ITEM: 6.6	REPORT SUMMARY MINOR VARIANCE APPLICATION FILE NUMBER A048/24
------------------	--

MINOR VARIANCE APPLICATION FILE NUMBER A048/24

CITY WARD #:	2
APPLICANT:	Francesco Cozzolino
AGENT:	Permitguys.ca Inc.
PROPERTY:	108 Jackman Crescent, Woodbridge
ZONING DESIGNATION:	See below.
VAUGHAN OFFICIAL PLAN (2010) DESIGNATION:	Vaughan Official Plan 2010 ('VOP 2010'): "Low-Rise Residential"
RELATED DEVELOPMENT APPLICATIONS:	None
PROPOSAL:	Relief from the Zoning By-law has been requested to permit a proposed walkway in the easterly side yard to accommodate access to a secondary suite. Relief is also required to permit an existing sunroom and shed located in the rear yard.

Site Plan

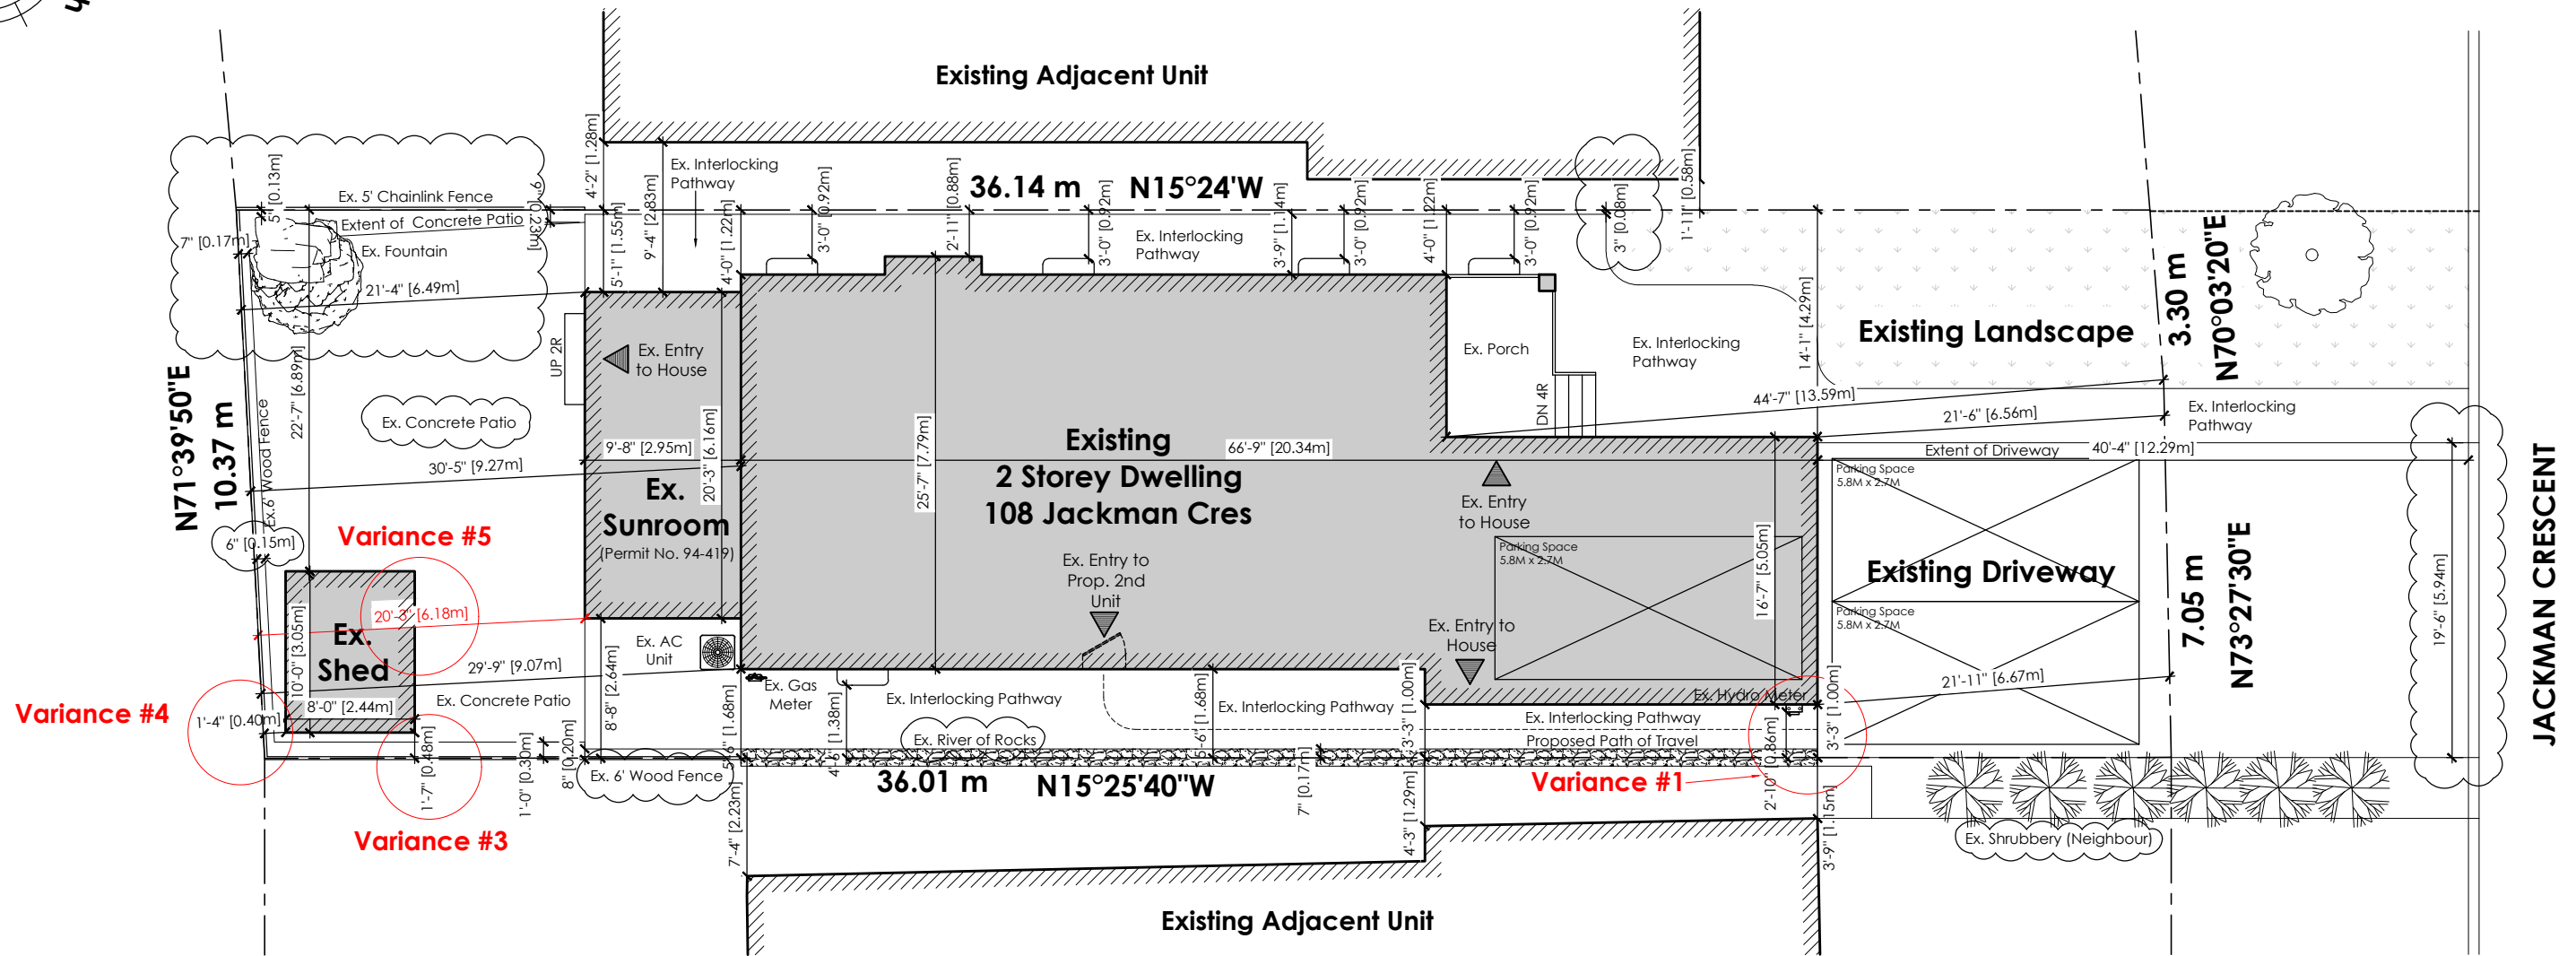
Zoning By-law 001-2021	
1	The Agent has confirmed that the height of the existing shed is 1.88 m.
2	Eaves and gutters appurtenant to the existing shed shall not encroach more than 0.5 m into a minimum required yard and shall not extend beyond the limits of the property.

The Development Planning Department ('Development Planning') has no objection to Variance 1 for the reduced width of the proposed walkway in the east interior side yard leading to an existing side entrance proposed to be converted into a secondary suite entrance. The walkway is proposed against the east interior side wall of the dwelling. The width of the interior side yard where the walkway and entrance are proposed is 1.68 m. The requested relief is proposed towards the front of the dwelling where the house/garage bumps out towards the east side lot line. The bump out maintains a 1.0 m setback to the interior side lot line, further narrowing to 0.86 m where the existing gas meter is located. Except for where the gas meter is located, the pathway maintains a 1.0 m width. The gas meter is of minimal height, which allows for the passage of larger items over it if needed. Therefore, the reduction of 0.34 m to the required walkway width is minor in nature and remains adequate to facilitate access to the secondary suite entrance at the side of the dwelling and the rear yard.

Development Planning has no objection to Variance 2 to permit an increased maximum lot coverage of 44.77%. The proposed 4.77% increase is to accommodate the existing sunroom addition (approximately 4.85%) and accessory shed (approximately 1.98%). Both structures are one storey, and as such provide minimal mass with respect to the surrounding rear yards. The existing dwelling accounts for approximately 36.24% of the

Development Planning has no objection to Variances 3 and 4 to permit the existing accessory structure (shed). Variance 3 is to permit a reduced interior side yard setback of 0.48 m and a reduced rear yard setback of 0.40 m. The shed is modest in mass and complies with maximum height and maximum lot coverage requirements within Zoning By-law 001-2021 for accessory structures. The proposed minimum setbacks from the interior side and rear lot lines for the shed provide sufficient space for maintenance access and are not anticipated to pose significant adverse impacts to the abutting property to the south (62 Jackman Crescent) and the east (110 Jackman Crescent) as there is no overhang over the property line. Potential adverse massing impacts anticipated from the shed wall's proximity to the interior and rear lot lines is further mitigated by the existing tall wooden privacy fence. Development Engineering Department has also reviewed the proposal and is satisfied that drainage will be maintained. As such, Development Planning is of the opinion that the shed will have minor massing and visual (privacy) impacts on the properties to the south and the east.

Variance 5 is to permit a reduced minimum rear yard setback for the existing sunroom (6.18 m). The 1.32 m encroachment into the required rear yard is anticipated to have minimal use and massing impacts on the neighbouring properties to the east (110 Jackman Crescent) and west (104 Jackman Crescent) as appropriate interior side yard setbacks are maintained, and the sunroom is generally in line with the rear wall of the dwelling at 104 Jackman Crescent. The reduction to the rear yard setback will not pose a significant visual impact to, nor impact the function of the abutting rear neighbouring property (62 Jackman Crescent) and will not adversely impact the functionality of the rear yard as sufficient amenity space remains.
